Agenda Item	6.1
Report No	PLN/015/20

HIGHLAND COUNCIL

Date: 9 June 2020

Report Title: 15/01202/FUL : HPG (Inverness) Limited
Former Fish Factory, High Street, Conon Bridge

1 Site Layout Plan
1 : 500

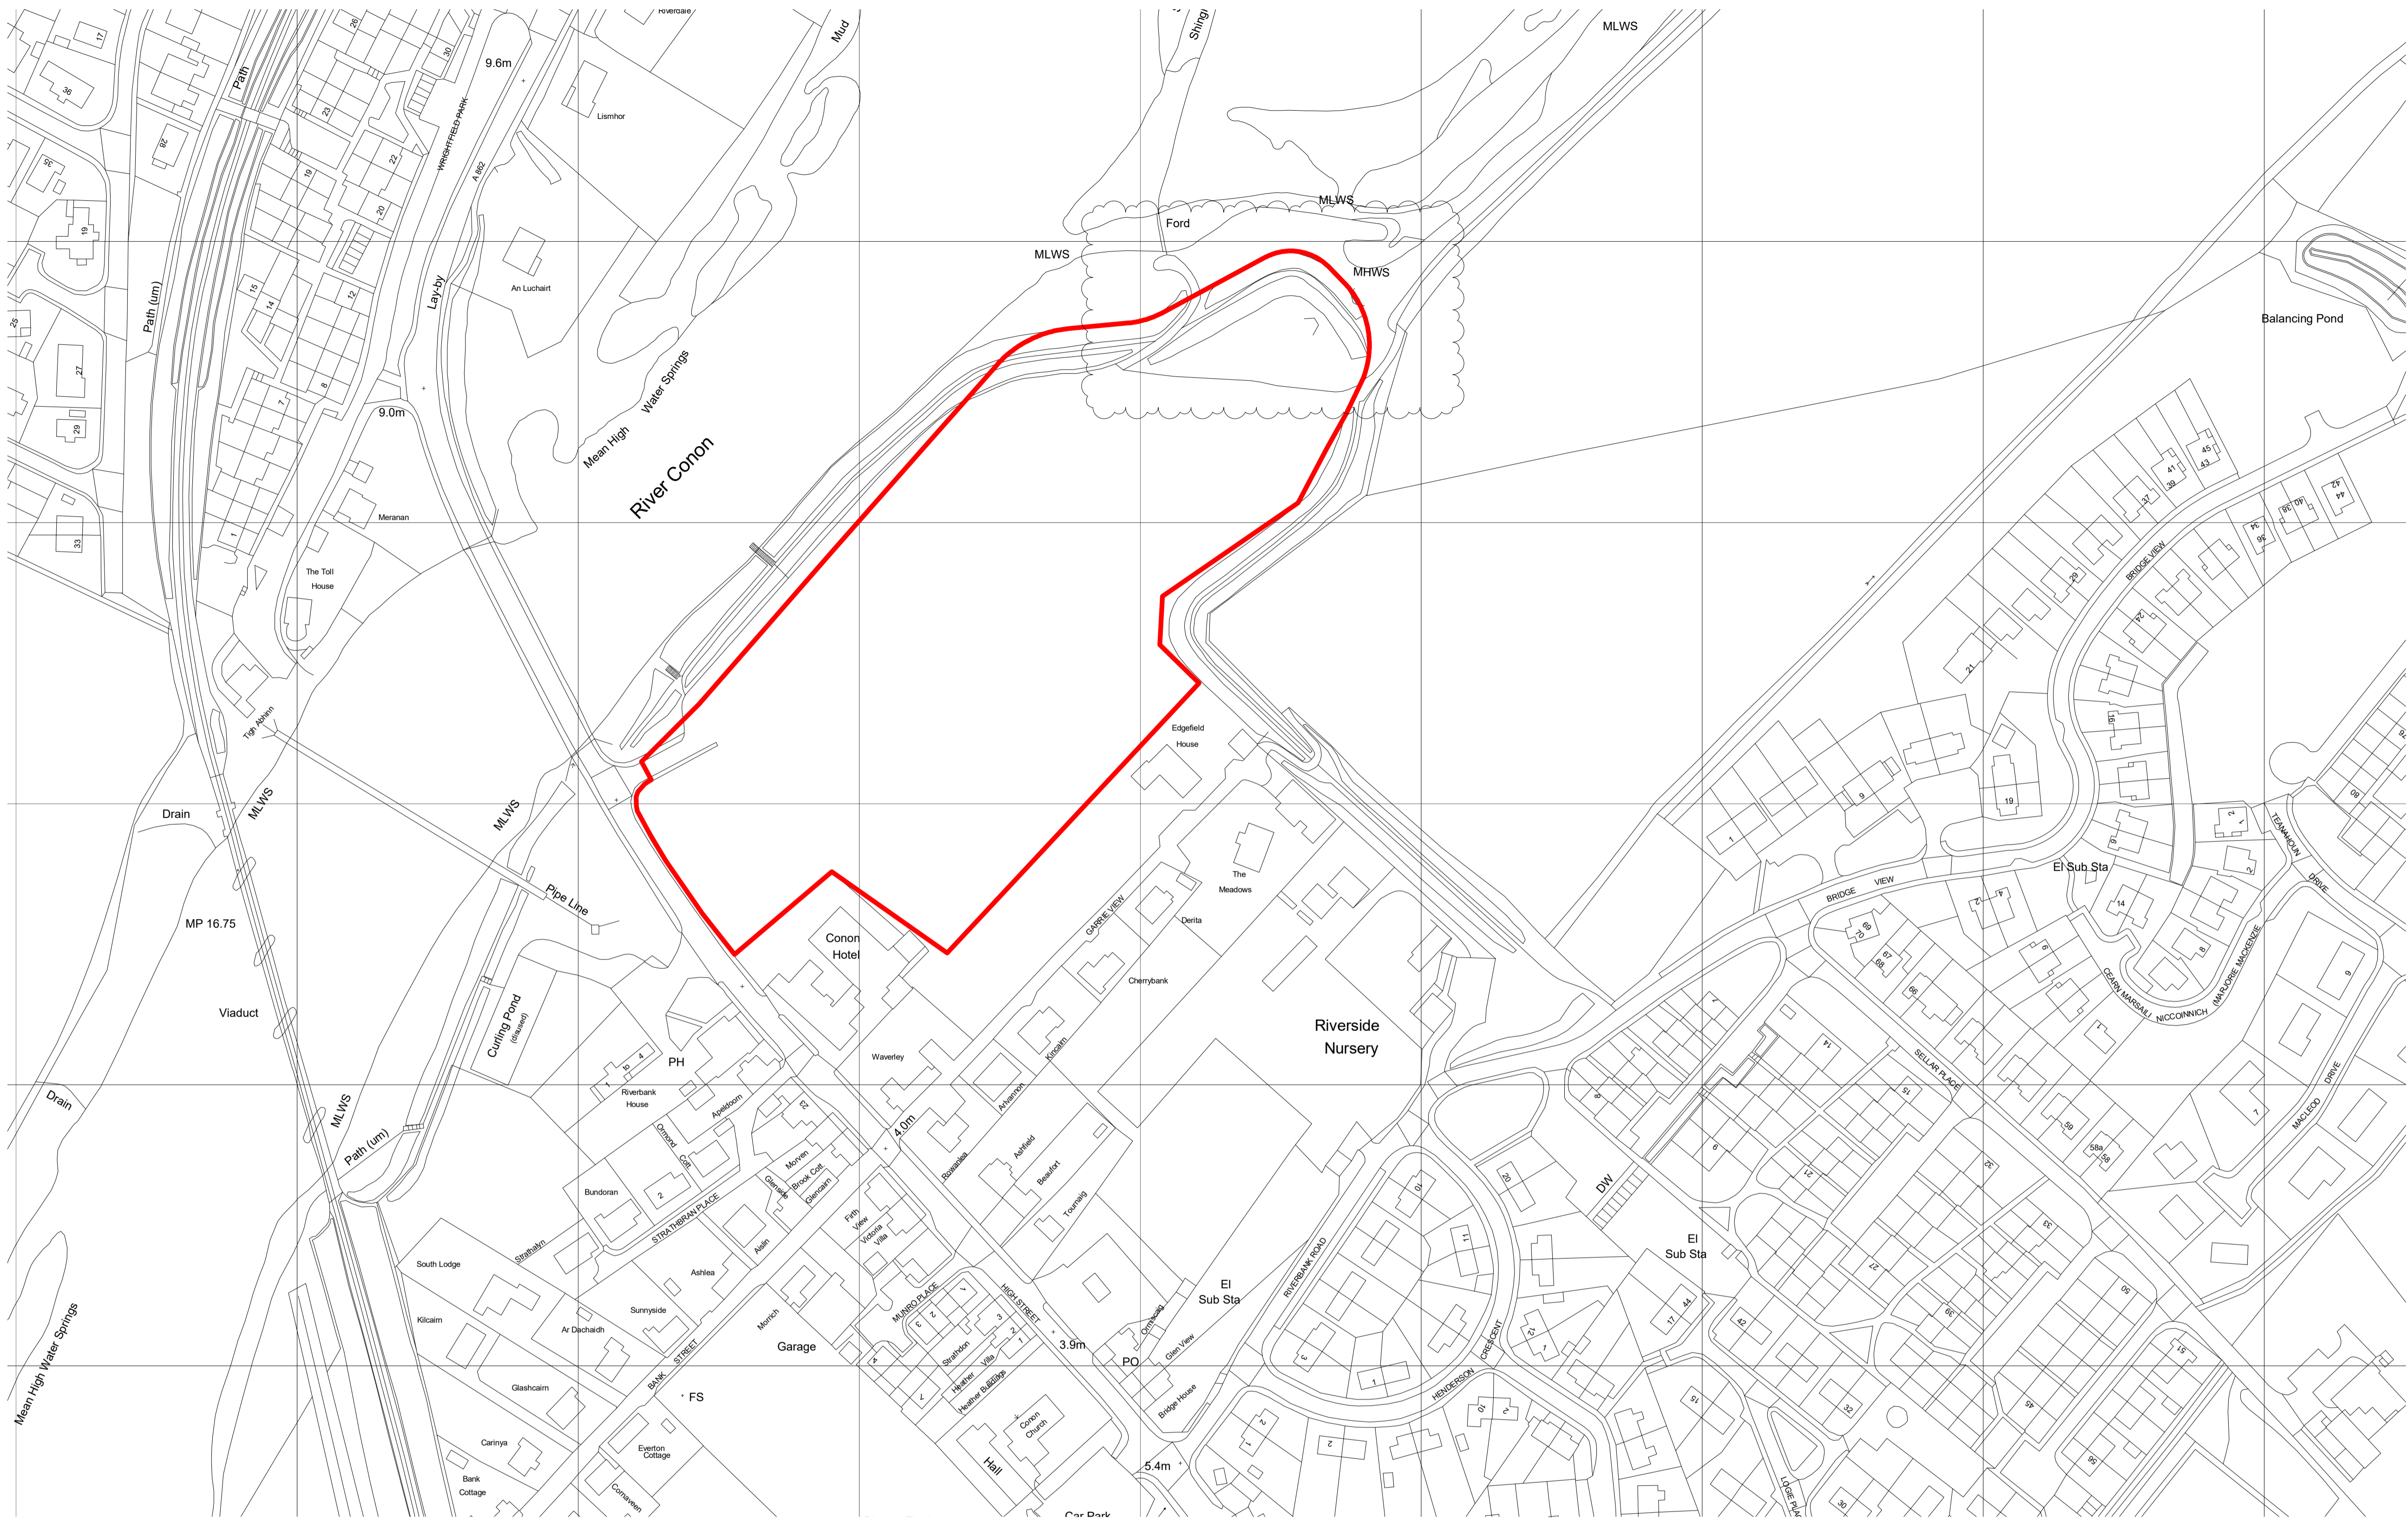
Dimensioned plans for car parking areas have been provided and are acceptable. The layout of the houses has been tweaked to allow sufficient space to park without overhanging onto footways which is welcomed.

15 spaces are required for the GP surgery and 5 each for the two retail units. However, accepting an element of shared use between the units, 20 spaces for the GP and retail element is acceptable. (Planning comment – whilst a business unit rather than a GP's surgery would require less parking it is considered desirable to retain the parking appropriate for a surgery in case the developer is able to secure a medical hub use for the site in due course.

Drawing No: A-P-00-G7-900
Revision: D
Scale: As indicated@A1

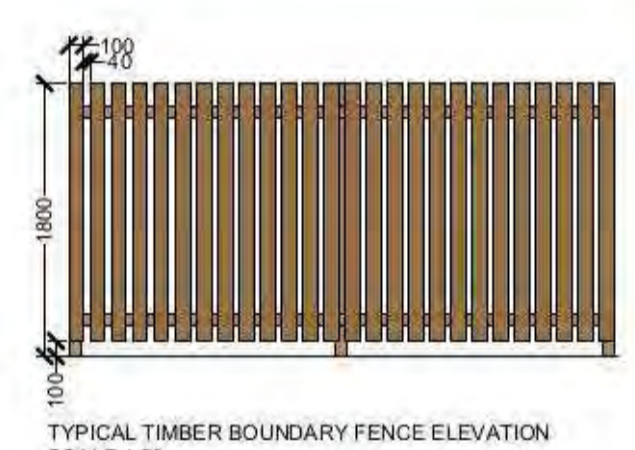
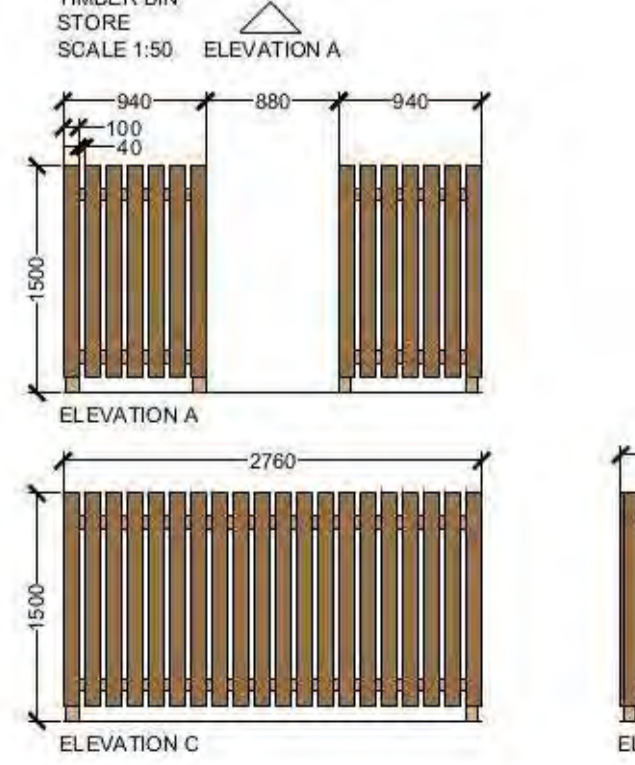
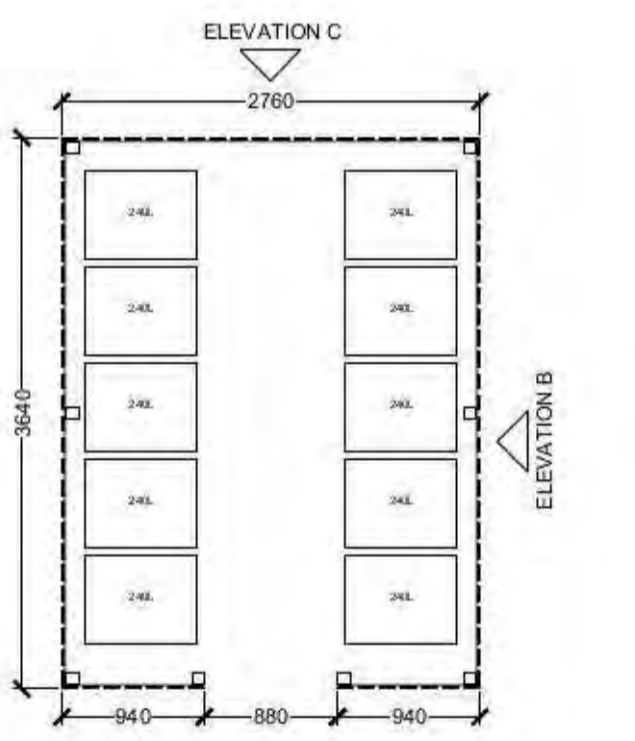
The Landscape Plan identifies all but four trees for removal. It is unlikely that any of the four trees would survive given their close proximity to proposed roads or buildings. Based on the information provided, all trees will be removed from site in order to accommodate the development. This ignores original advice which sought to retain an element of existing tree cover along the road frontage. Should you be minded to accept this tree loss in order to accommodate the scale of development within the site, I would place an emphasis on securing a quality landscaping plan. The plan submitted is indicative only and requires significant work in order to provide the level of information expected. Given the scale of development, I would encourage the applicant to employ the services of a landscape consultant. Further opportunities for public open space need to be identified, which may involve the loss of some units. There is significant potential to create a wetland habitat around the SUDS basin. Consideration needs to be given to the treatment of the eastern boundary once the existing screen is removed. This may involve native hedge planting and/or the planting of individual specimen trees.

Latest Landscaping Plan submitted 06.09.2017 is indicative at best and demonstrates benefits of engaging a landscape architect. None of the points I raised have been addressed so I have nothing to add to my previous comments. If the removal of the trees as proposed is accepted, this should be conditional upon a good quality Landscaping Plan being submitted. This could be secured by a suspensive condition. I remain concerned about the impact on the trees owned by the Hotel which will create problems if left to be addressed as a suspensive condition. These provide some screening for the hotel but the current proposals are likely to cause direct damage resulting in removal. Post development there is also likely to be continued pressure to fell remaining trees due to lack of light, views and safety concerns.

The Landscaping Plan shows all but four trees, one beside the existing access, two beside the proposed access and one to the north east edge of the site being removed. Given their proximity to the roads and building the Forestry Officer considers they may not survive. The existing mature tree at the existing access has the greatest chance of survival as it will be least affected by the proposals. He advises that if this approach is to be accepted to accommodate the level of development proposed, he suggests that emphasis should be placed on securing a quality Landscaping Plan and comments that the plan submitted is indicative only and requires significant work to provide the level of information expected.

boundary treatment provided as this will provide more garden space and better daylighting for future residents. The Landscaping Plan shows a timber boundary fence provided once the hedge is removed which is considered acceptable.
